NOTICE OF PLANNING & ZONING COMMISSION MEETING

City of Cumming

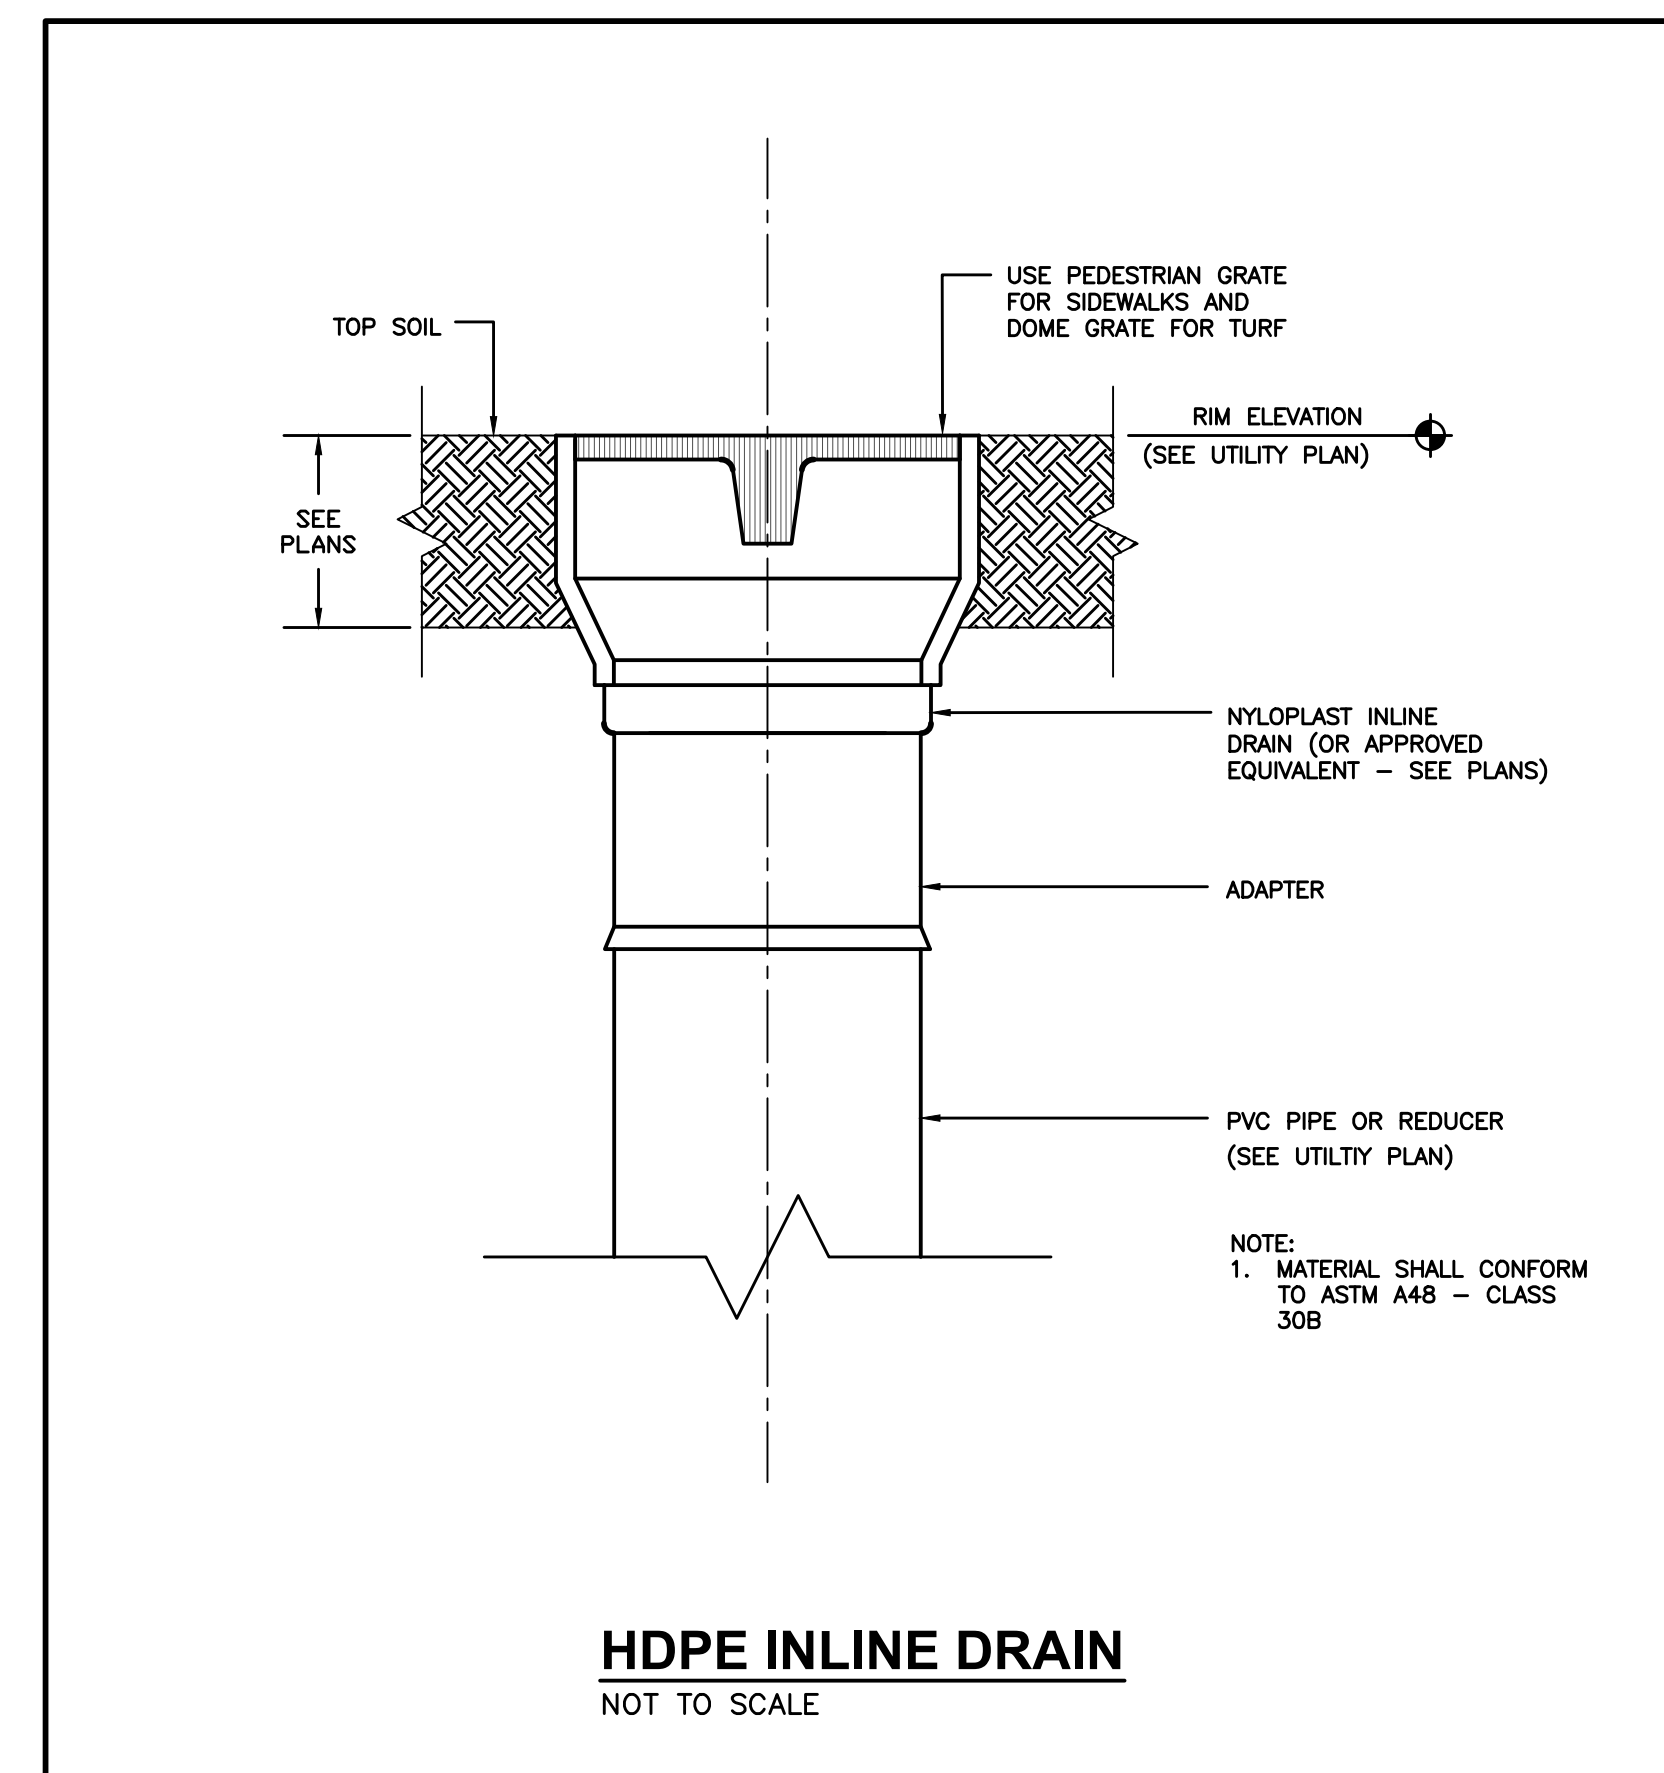
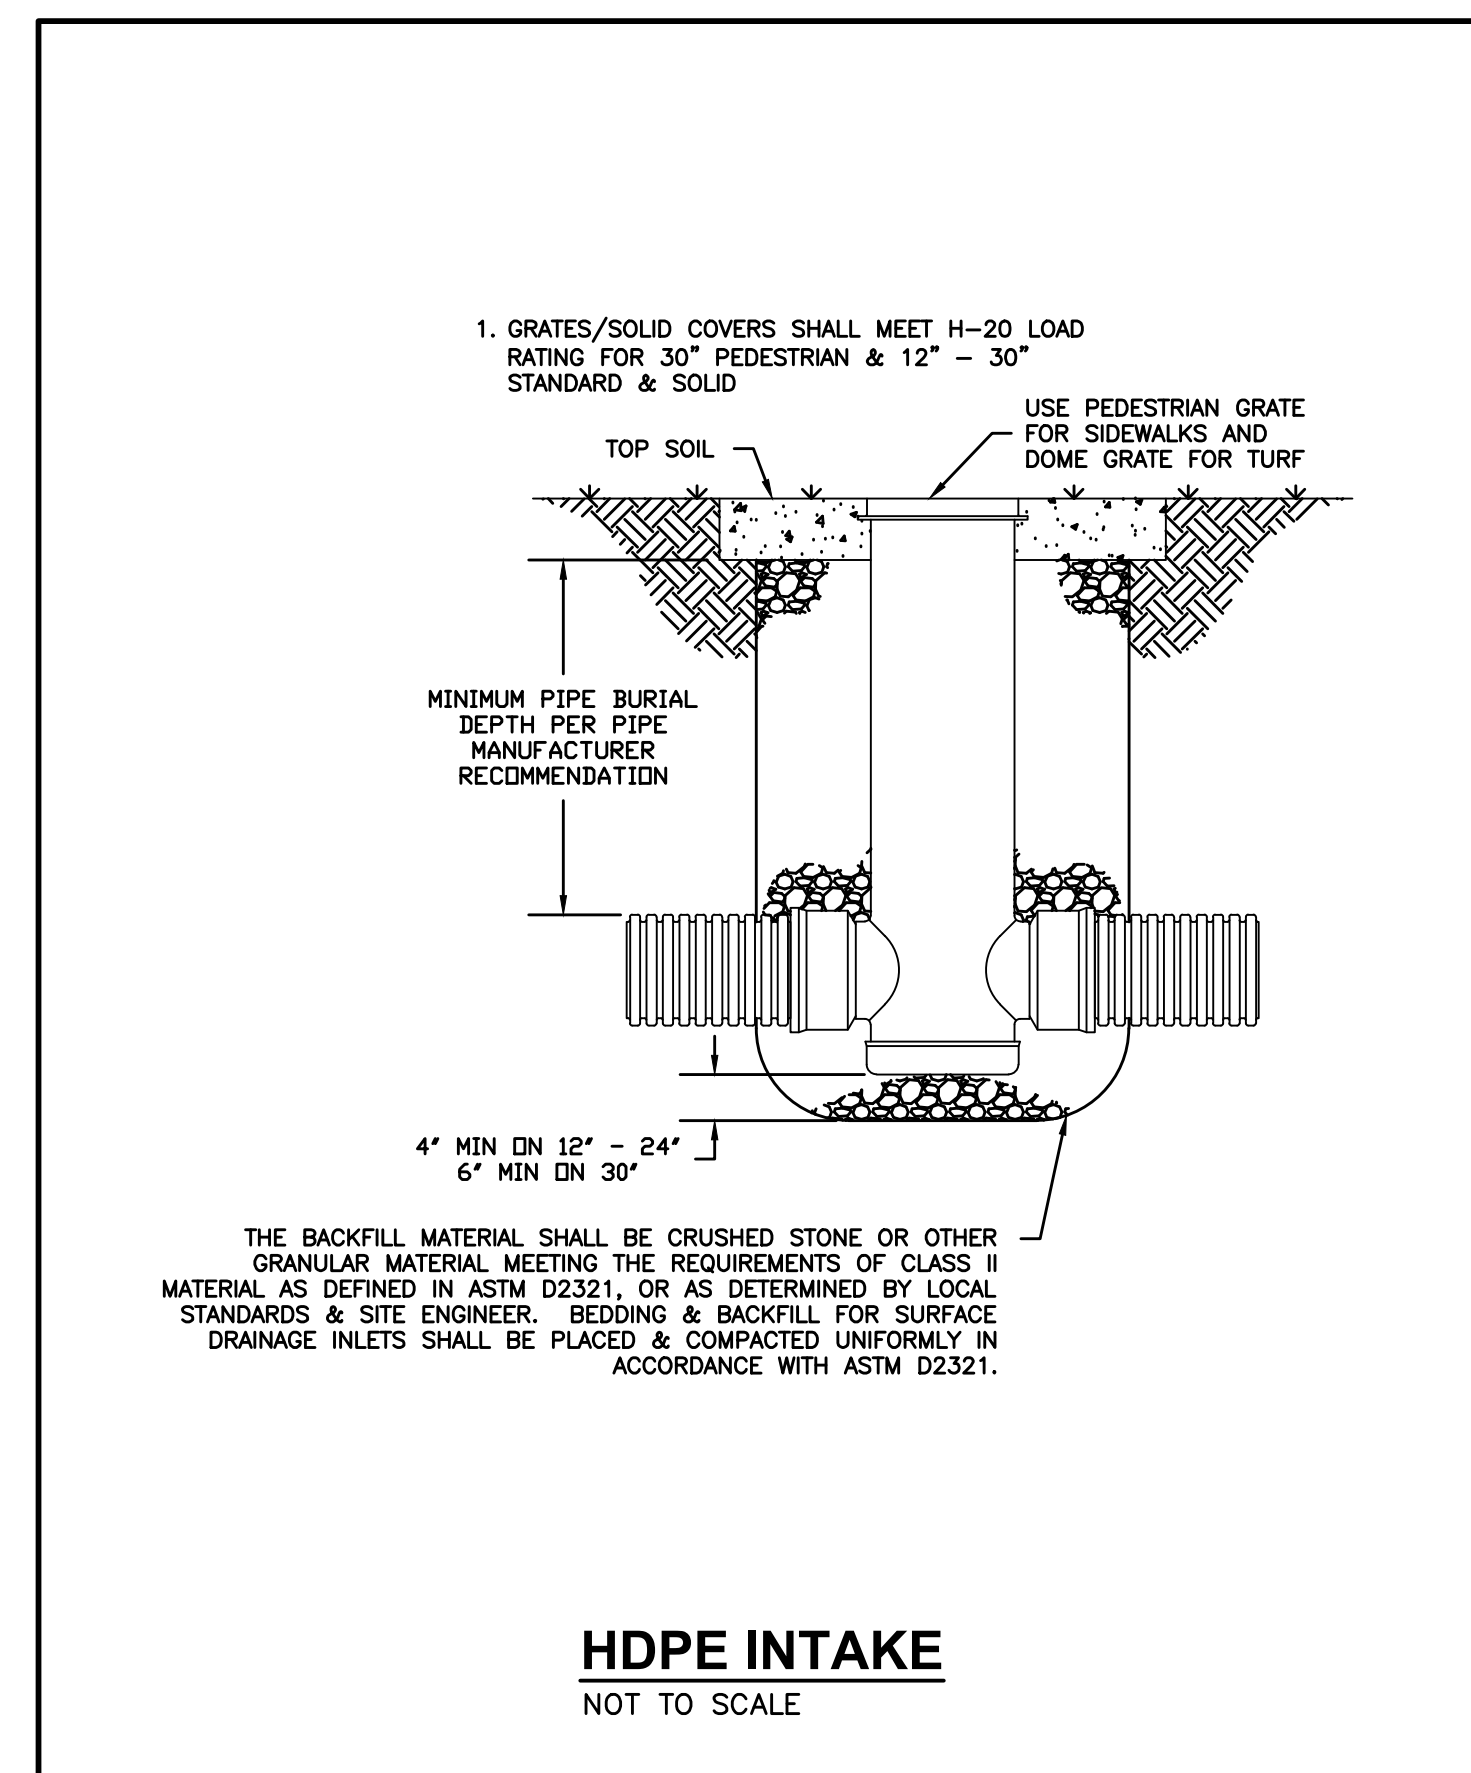
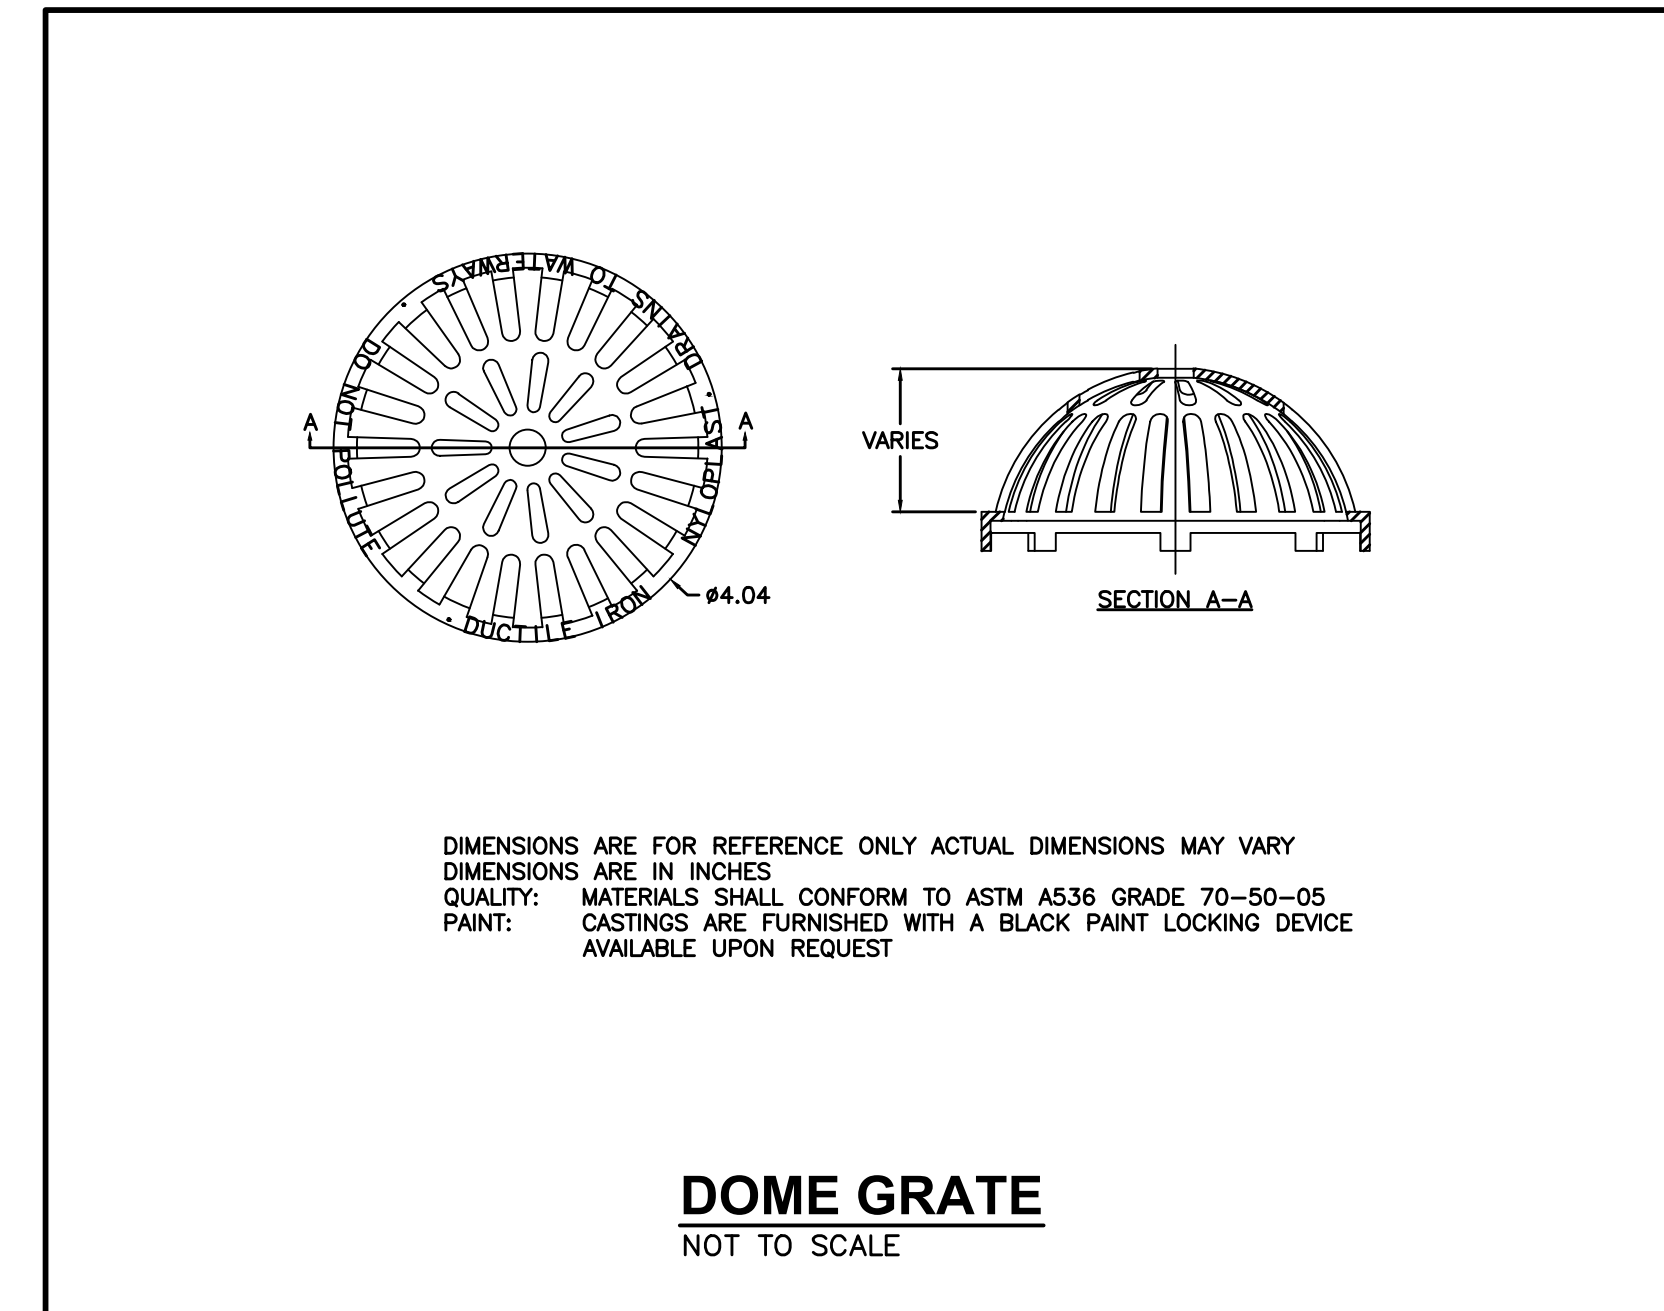
FILE: H:\2024\2405385\DWG\2405385-SITE PLAN.DWG COMMENT: DATE PLOTTED: 1/29/2025 6:00 PM PLOTTED BY: ROSALIA STONEBERG DESIGNED BY: ENR
